# Service Bulletin

Bulletin No.: 09-07-30-001F

**Subject:** Transmission Shudder or Bucking Feel (Follow Procedure Outlined Below)

**Models:** 2009 Cadillac Escalade  
2008-2009 Chevrolet Tahoe  
2008-2009 GMC Yukon  
Equipped with 2 Mode Hybrid Automatic Transmission (RPO M99)  
Built Prior to Serial Date 8010017028

2535182

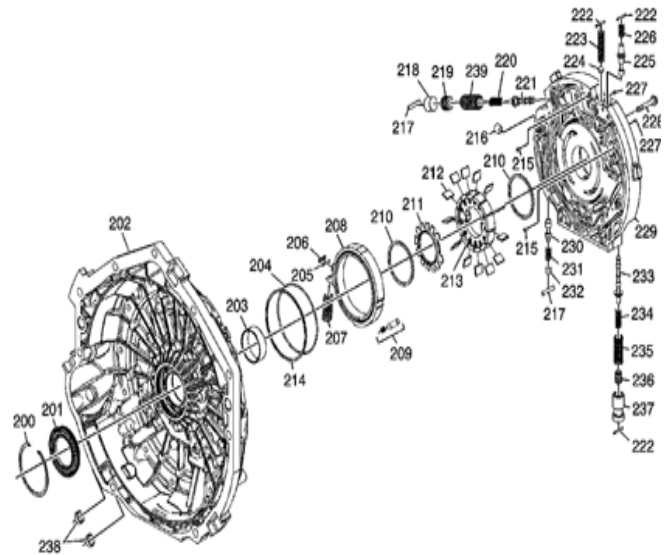
To verify the concern is caused by the orifice, monitor the Hybrid Low 1-2 clutch slip speed (clutch 1 on the scan tool). Normal clutch slip speed should be 0 rpm. If the slip speed varies either positive or negative slip rpm, or causes other clutch slip speeds to read erratic, the orifice is most likely restricted (see scan tool screen shot below showing variation of the clutch 1 slip speed (circled area). Normal reading would have a flat line (0 rpm).

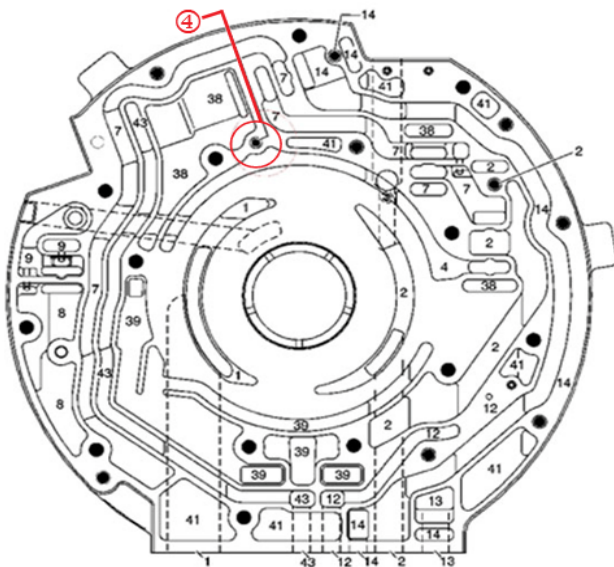
3. Remove and discard the orifice cup plug in the pump cover. The location is shown above (callout #4).

4. Replace the fluid pump cover kit. The cover kit is shown as part number 229 in the picture above.
5. Install the torque dampener housing to the transmission.
6. Install the transmission.
